INDIANA UTILITY REGULATORY COMMISSION REGULATORY COMMISSION

PETITION OF COMMUNITY UTILITIES OF )  
INDIANA, INC. FOR (1) AUTHORITY TO )  
INCREASE ITS RATES AND CHARGES )  
FOR WATER AND WASTEWATER )  
UTILITY SERVICE; (2) APPROVAL OF )  
NEW SCHEDULES OF RATES AND ) CAUSE NO. 44724  
CHARGES APPLICABLE THERETO; AND )  
(3) APPROVAL OF NEW DEPRECIATION )  
RATES )

**PETITIONER'S RESPONSE TO COMMISSION DOCKET ENTRY**  
**QUESTIONS DATED FEBRUARY 2, 2017**

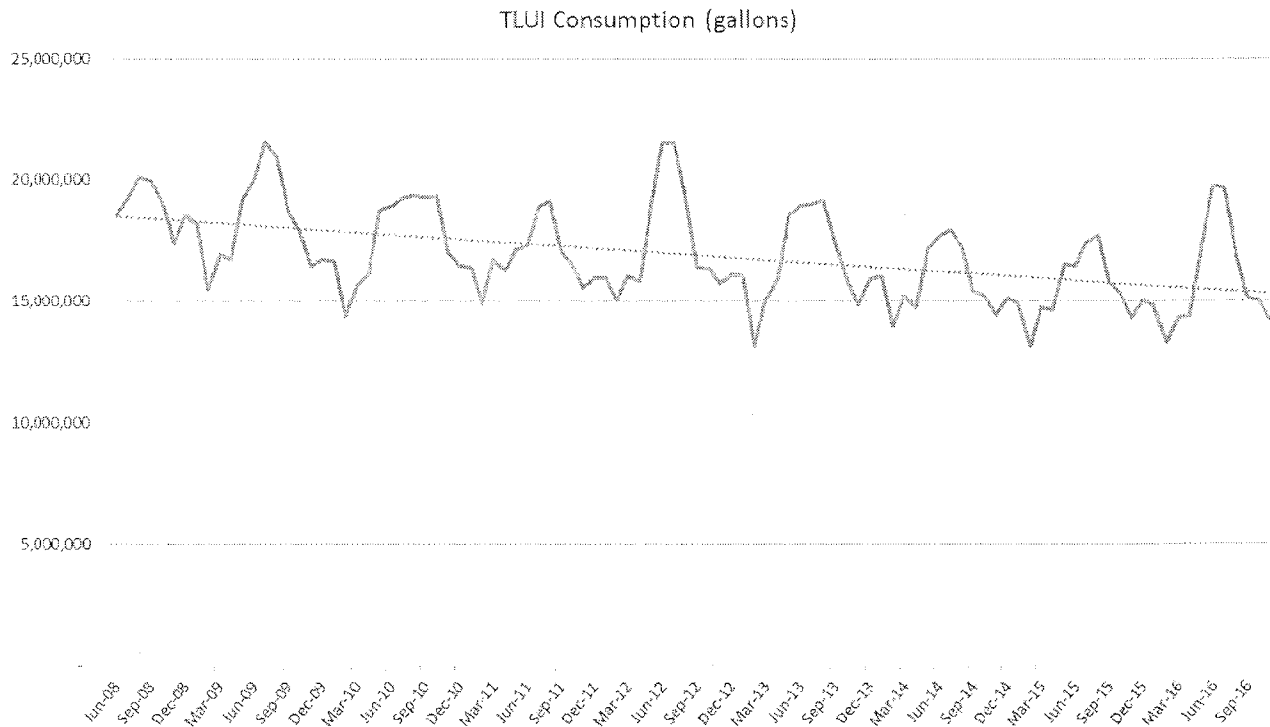
Within the Twin Lakes water system, please discuss whether demand is increasing or decreasing.

Please see the below graph for reference “TLUI Consumption (gallons)”, which depicts total customer consumption at TLUI over the last 8.5 years (June 2008 – November 2016). Although the trend is decisively down, at an average year-over-year change of approximately -2%, as evidenced by the summer peak in 2016 weather events, or lack of weather events, may cause deviations from the trend. The 2016 spike in customer consumption was driven by abnormally low rainfall in the June and July periods.

The Company’s records indicate consumption and rainfall are negatively correlated in the summer months, and although there was approximately 9” of rainfall in the June and July periods (which is not out of line with historical norms), 50% of this rainfall occurred in the last week of July. To conclude, although the demand is decreasing, there is clear evidence that prolonged periods of abnormally low rainfall in the summer periods will cause demand to spike and deviate from the trend.
